Executive Director's Recommendation

Commission Meeting: May 3, 2012

United States Museum of the Army
Fort Belvoir, North Post
Fairfax County Parkway and John J. Kingman
Highway
Fairfax County, Virginia

Final approval of building plans

Sightline from Fairfax County Parkway in front of Museum Building

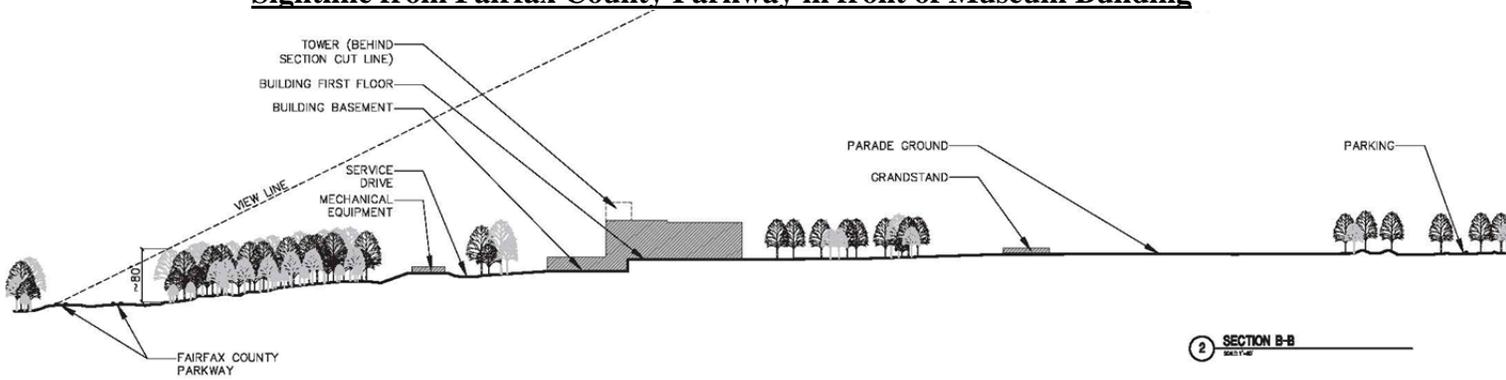
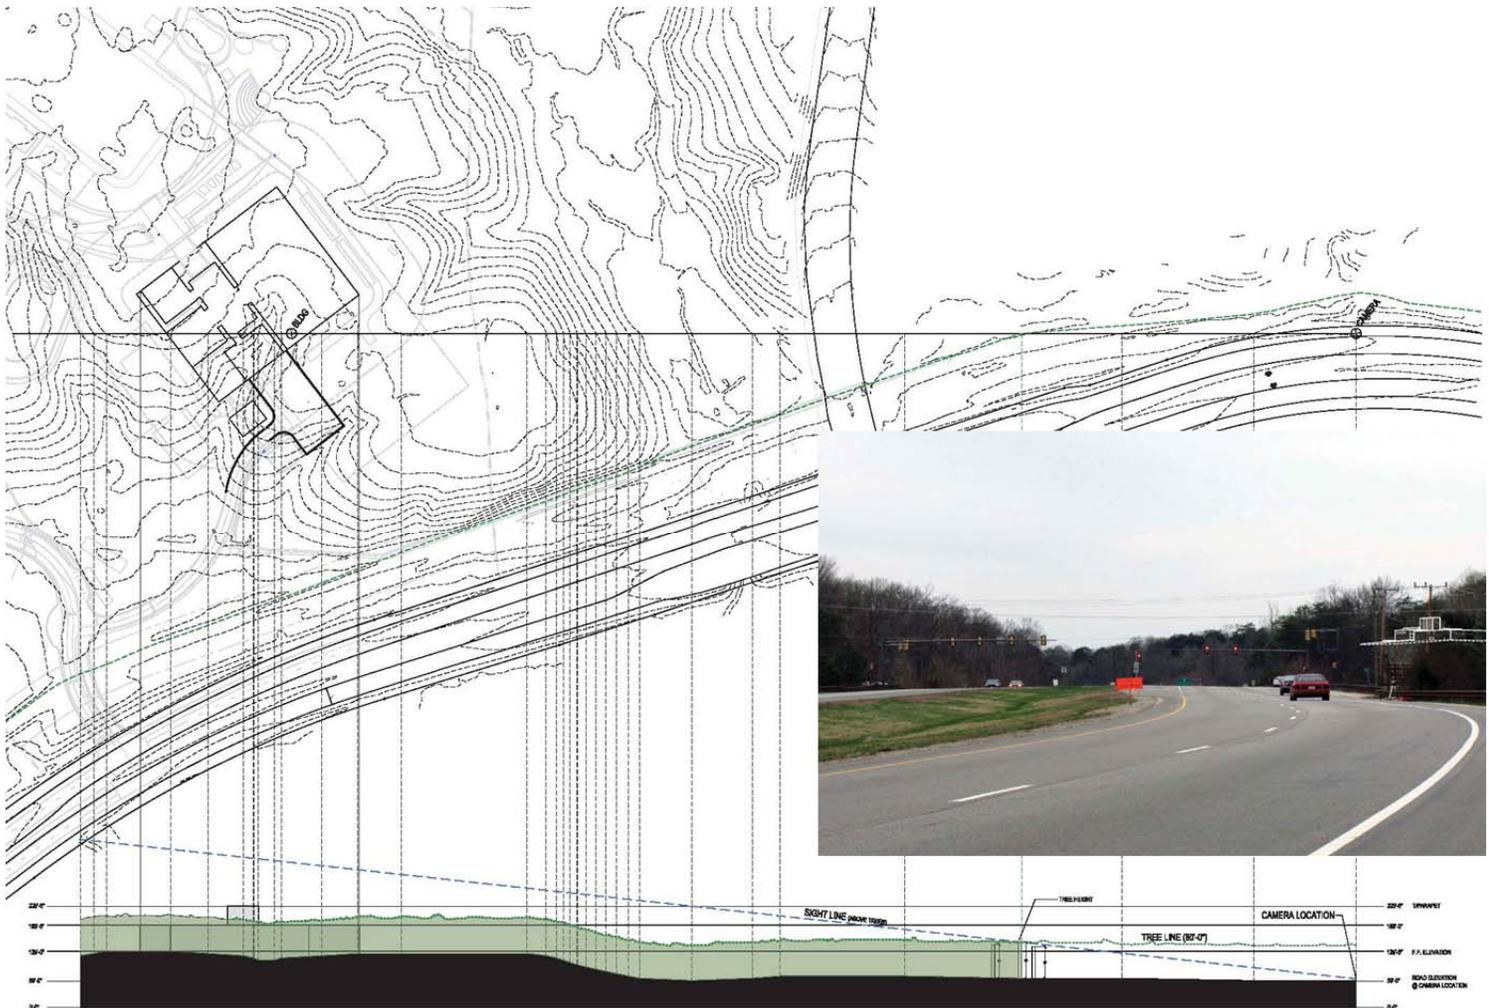
As requested by staff in order to evaluate the impact the building would have on views along the Fairfax County Parkway, the Army has submitted site sections and view simulations of the museum building. The sections indicate that the museum building will not be visible from the Parkway due to the distance away from the Parkway and the existing vegetation along the Parkway.

Stormwater Management Location

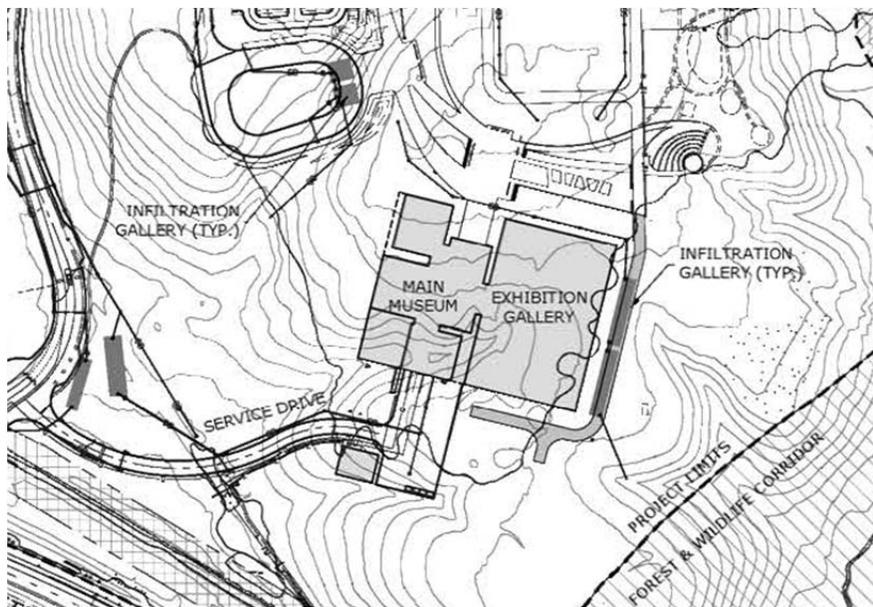
In regard to the stormwater management for the building and the site, the Army will meet the requirements of the Energy Independence and Security Act (EISA) Section 438, which regulates stormwater on federal facilities. The Army will also meet Virginia and Fairfax County stormwater management techniques. The Army will meet all requirements for Total Maximum Daily Load requirements outlined in its MS4 permit. For the building stormwater, the Army is proposing two infiltration galleries on the east side of the building. The Army intends to retain the 95th percentile rain event onsite.
